27 April 2018

RE: Response to Department of Planning and Environment Request for Response to Submissions (SSD 8440) at 42 Honeysuckle Drive, Newcastle 2300
REF: 17058

Figure 1 – Height Limit Exceedance

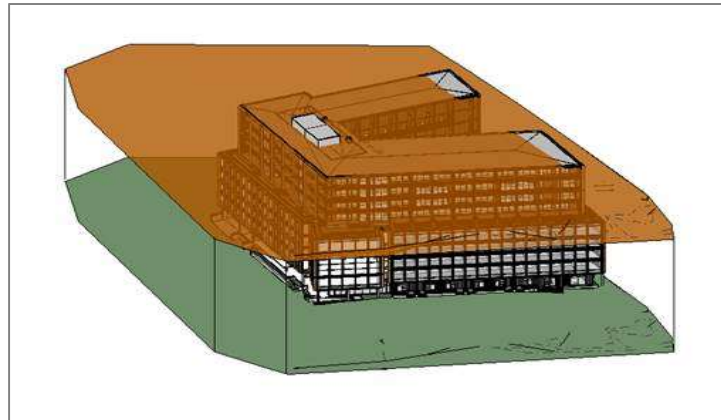
- *Provide further detail in plan and section form clearly identifying and quantifying the parts of the building which exceed the maximum height of 30 metres (m).*

Attached in the architectural are a section referenced SK.010 which indicates the 30m height limit from ground level with portions that exceed the height limit in green. As can be seen the only portions of the building that exceed the 30m height limit are a small portion on the southern end of the towers, and the water tank located on the rooftop.

To further illustrate this Figure 1 shows a 3D model with a plane at 30m showing the portions of the building that exceed the 30m height limit. As can be seen the exceedance is very minor in nature. Further justification for the height exceedance can be found in the clause 4.6 that is also attached.

Figure 2 – View analysis indicating impact from adjoining properties.

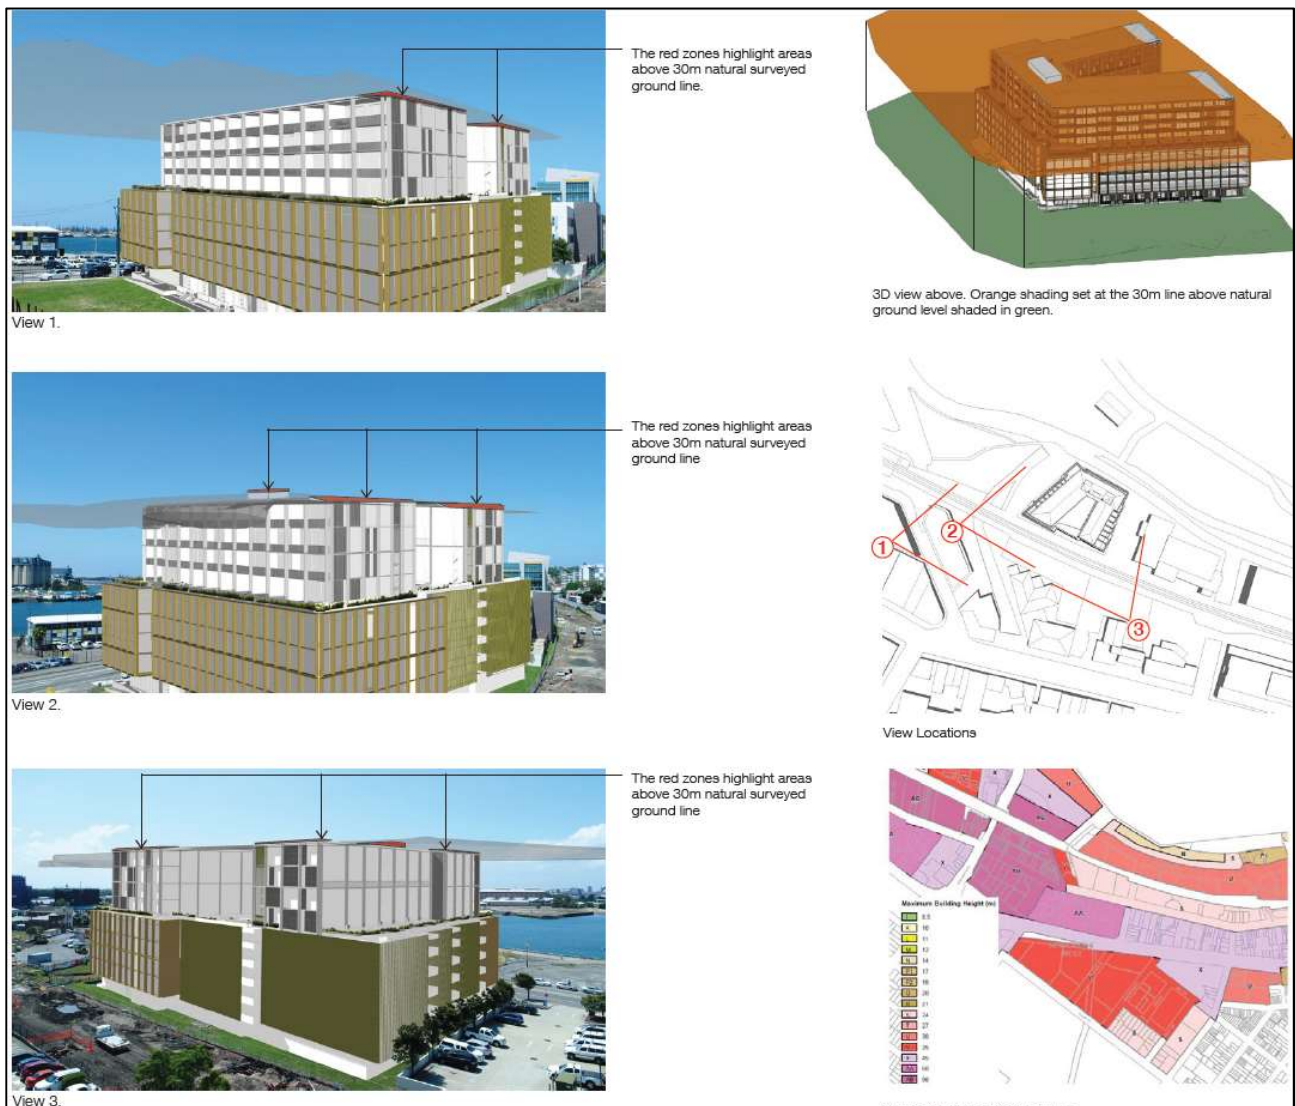
- *Provide an analysis of view impacts associated with the proposed variation to the 30m height standard on existing nearby residents, noting the concerns raised about view loss in public submissions.*

Additional view analysis drawings have been prepared to demonstrate the minor impacts caused by the height variation. These have been prepared taking the individual submissions raised by the

public into consideration (see Figure 2). These can be found in Attachment D, within the Bates Smart report.

Figure 3 – Drop-off area crossovers

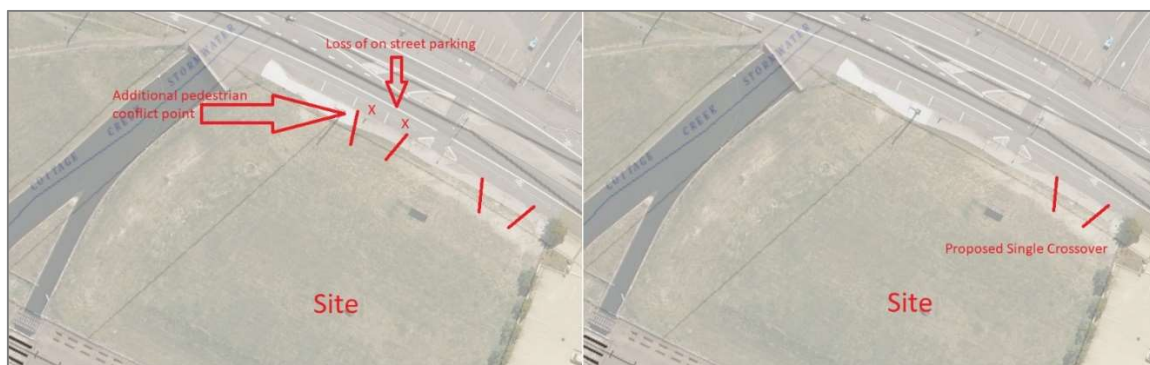
- *Provide any further consideration of the proposed hotel drop-off area on Honeysuckle Drive, including any options to provide this facility on site. Any proposed or relocated drop off area must include details of operation and management of this area and measures to minimise off site impacts.*

Consideration was given at the time of concept design as to the location of any hotel drop-off/collection area. Options were explored for having the drop-off area on site compared to having it within the road reserve.

The design that involved the drop-off area on site required a second driveway crossover on to Honeysuckle Drive (see Figure 3). This concept was not further explored as the second crossover would create an unnecessary pedestrian conflict point. Currently there are only two carparking spaces located along the frontage of the site. By necessitating a second crossover these two spaces would consequently be removed. In light of the existing shortage of parking in the vicinity it was considered unacceptable to remove any street carparking spaces.

Having a drop-off area on the road means that on street parking, while it will only be short term, will remain. The intention of the drop-off area is purely for immediate drop off and collection of guests. There are other short term spaces provided on site for guests who drive to the hotel and then check in. These spaces are separate from the resident and public carpark.
